CONWAY
HISTORIC DISTRICT COMMISSION
NOVEMBER

CONWAY HISTORIC DISTRICT COMMISSION MEETING

OLD CONWAY DESIGN OVERLAY DISTRICT CERTIFICATE OF APPROPRIATENESS REVIEW OLD CONWAY VILLAGE, LP

607, 675, 725, & 819 SIEBENMORGEN ROAD;
(755 SPRUCE STREET)

Applicant provided photo of the properties

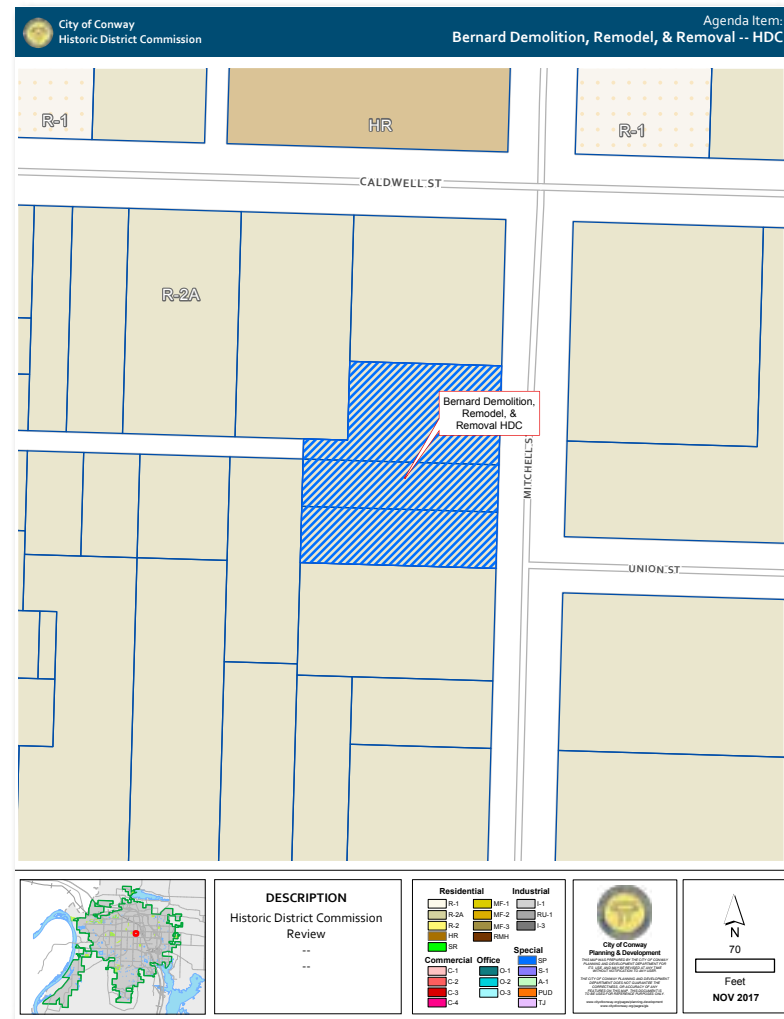
The applicant is seeking HDC approval to demolish the dilapidated garage on the southwest side of 857, demolish a storage building at the rear of the property, remove the unoriginal sunroom/laundry addition on the rear of 857, and move 853 Mitchell; a 617 square foot cottage off the property.

General comments. The elderly couple that owned the property deceased a few years ago and since that time, the property has been neglected. The applicants would like to generally clean up the property and remove the severely deteriorated items as stated above. The intent is to make the property presentable in hopes of attracting a buyer that will restore the residence.

Staff recommends approval of the planned demolition and building moving with the following conditions:

1. Demolition of the non contributing garage and storage building shall be allowed.
2. Demolition of the non-original sunroom/laundry room shall be allowed.
3. 853 Mitchell - A non-contributing 617 s.f. cottage may be removed from the property.

Site Plan showing project locations

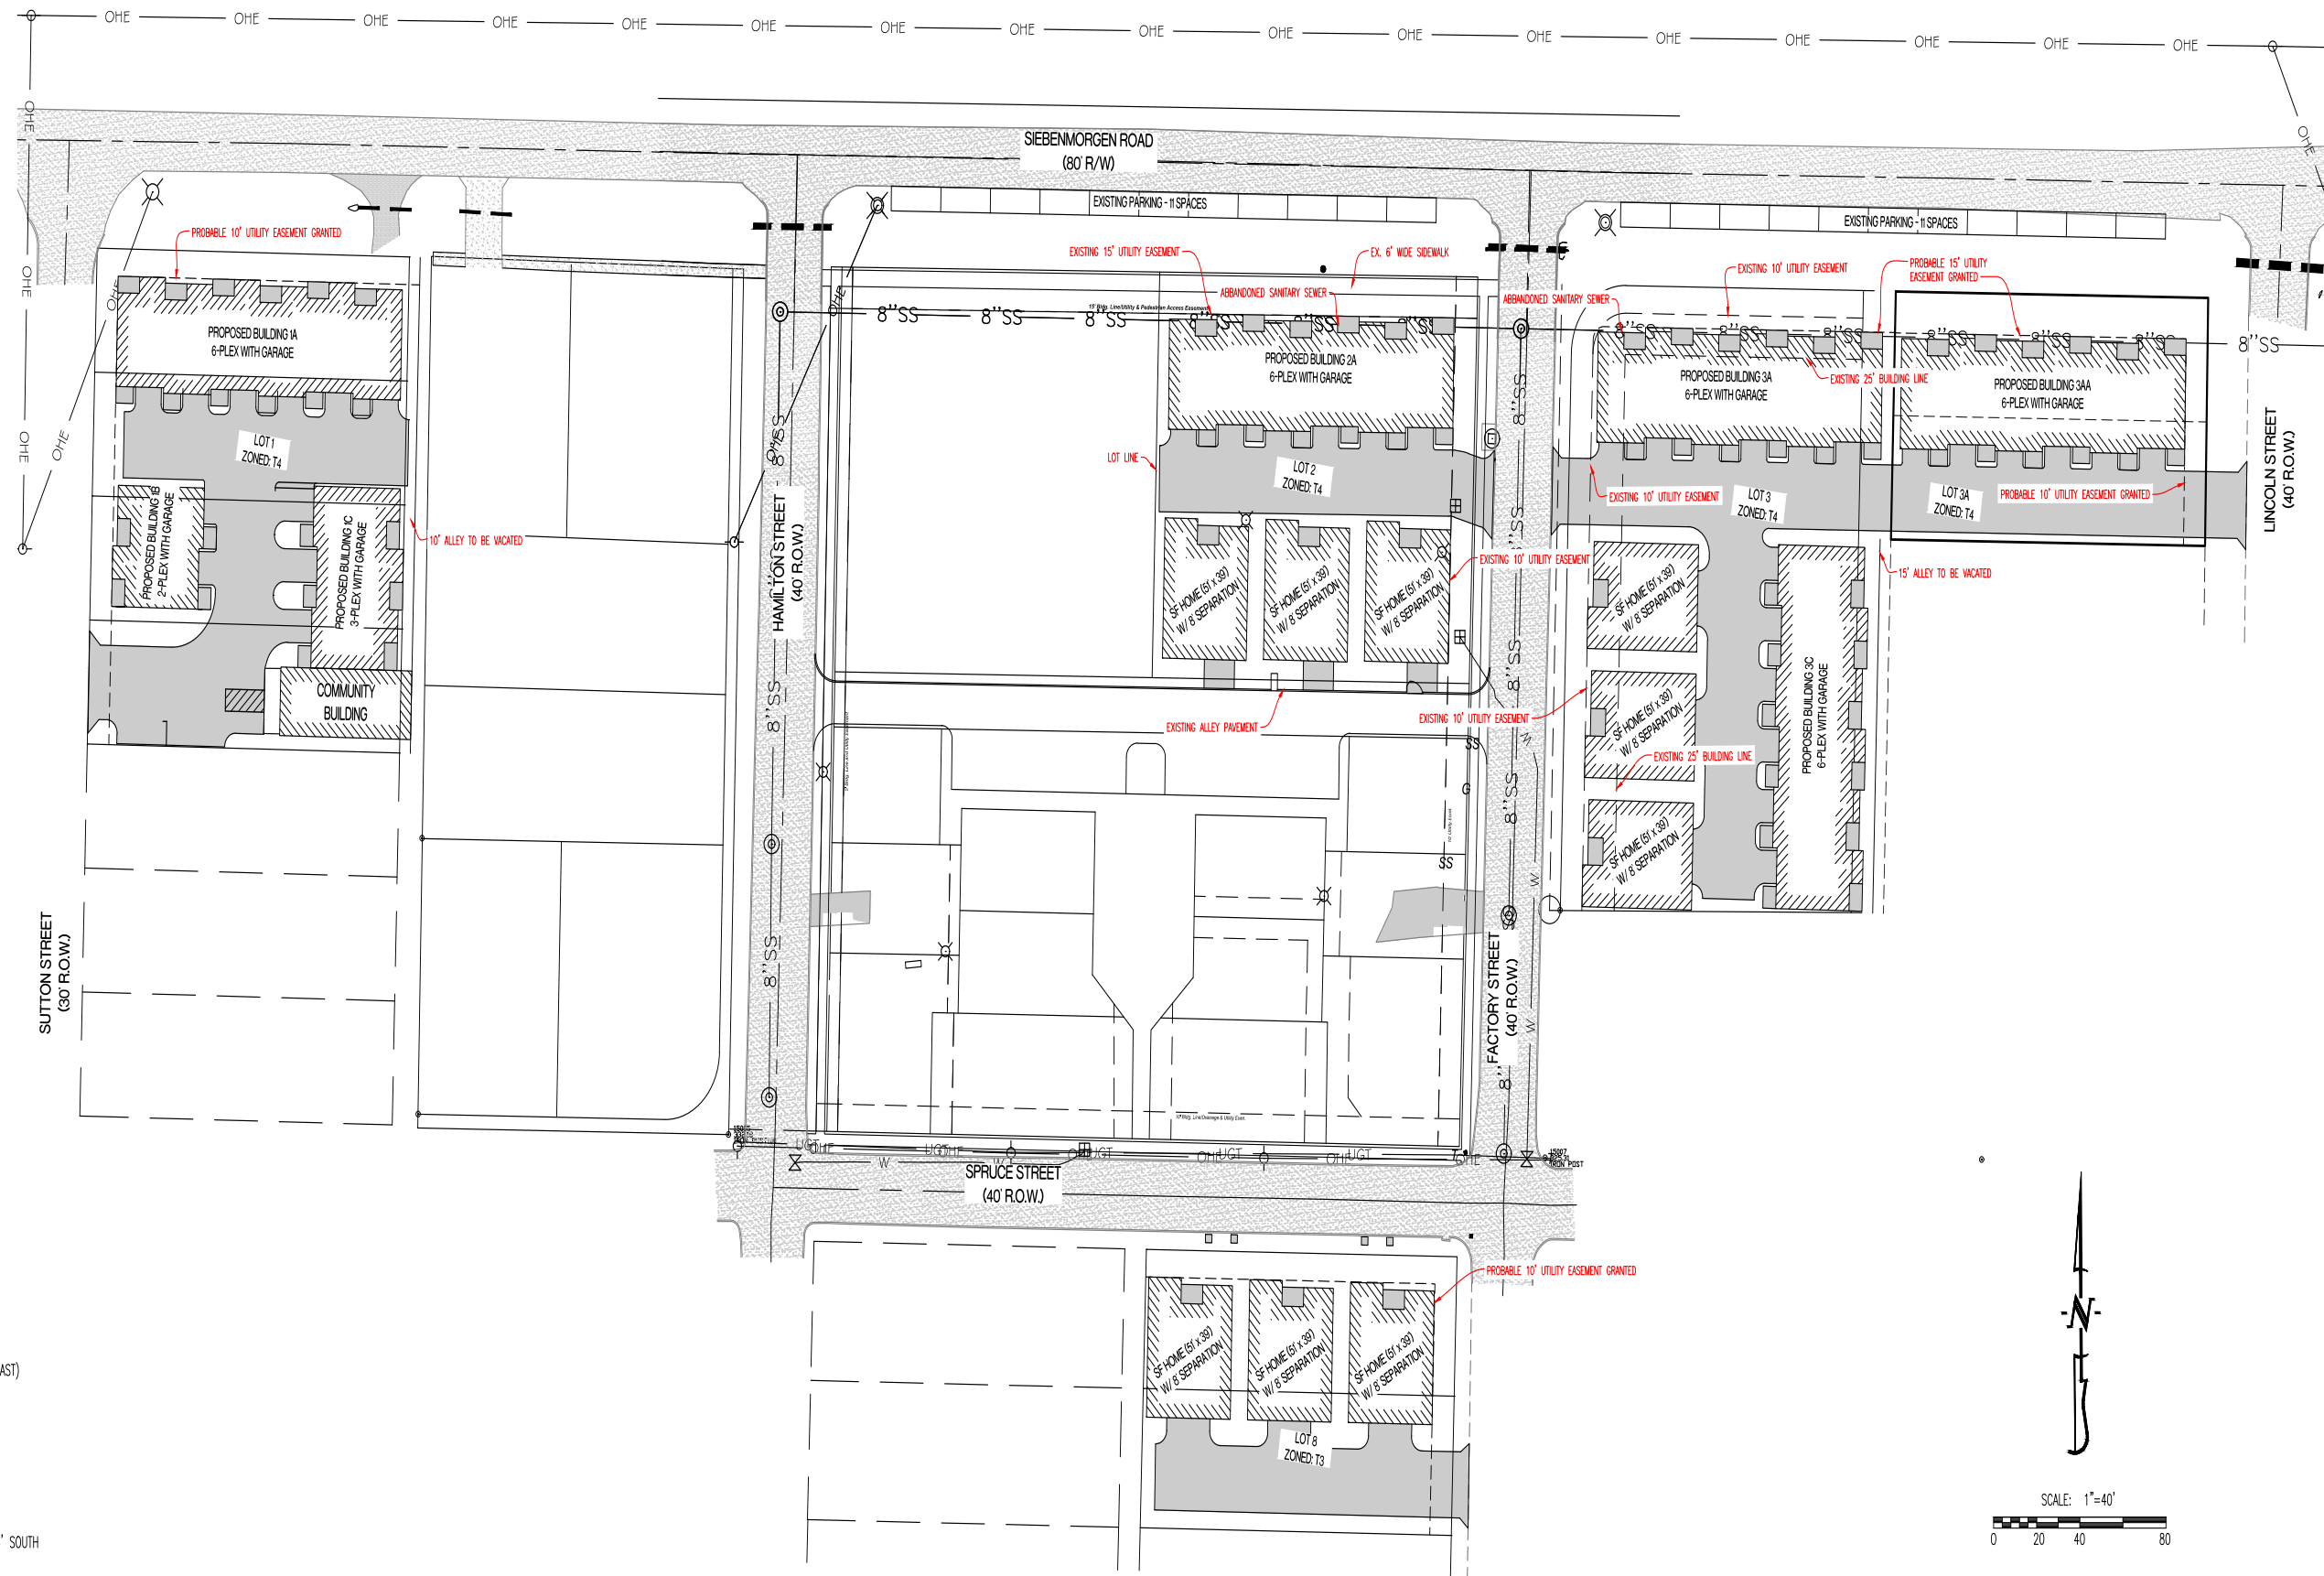
Orientation. The direction in which the front of a building faces. Most townhomes are oriented to face abutting streets. However, 3 units are facing internally with the "front" facade facing abutting property (Lots 1, 2, and Lot 3. The rear of some units on Lot 1 and 3 will be facing the abutting property. The front facades of the proposed single family homes on Lot 2 are shown facing internally.

Alley. There are 3 unbuilt alleys and one newly constructed alley in the project area. An alley in Lot 1 and part of an alley in Lot 3 will need to be closed in order to construct as proposed. The City Council will consider the alley closing requests at their November 28 meeting. The newly constructed alley should likely be used as the "front" of the single-family residences in Lot 2.

- The six unit townhomes on Lot 1 have been reoriented with the long side running parallel with Siebenmorgen. (A change since the October presentation)

- The community building attached to a 3 flex structure in the southeast corner of Lot 1. This creates a structure with better massing and scale than the originally proposed 5 flex with the attached community building.

- The 3 single family residences on the south side of Lot 2 are facing inward. There has been discussion concerning turning these facades south to face the alleyway.

- The 5 unit structure on Lot 3 closest to Factory Street was changed to 3 single family residences. This helps “soften” the transition from townhome to single family moving south into the neighborhood.

- 3 single family residences are shown on Lot 8. This would be necessary to create additional housing units in-lieu of not placing the Factory Street facing townhome on Lot 3. The driveway access area could be reduced from the 24 feet wide, as shown, to a reduced alley width of 16 feet. The existing 10 foot alley on the west side of the property could possibly be developed to provide access to a reduced size rear alley.

1. Setbacks will need to be determined. The HDC could allow the Director of Planning to determine and approve based on the initial HDC review and approval. Setbacks, easements, etc will be recorded as part of the platting process.
2. Tree preservation, remediation, possibility of street trees. Tree preservation, remediation, etc could be determined and approved as part of Planning Staff development review.
3. First floor heights 9 foot minimum.
4. Front entry heights shall be a minimum of 16 inches, higher is preferred.
5. All structures shall be clad with cement board siding.
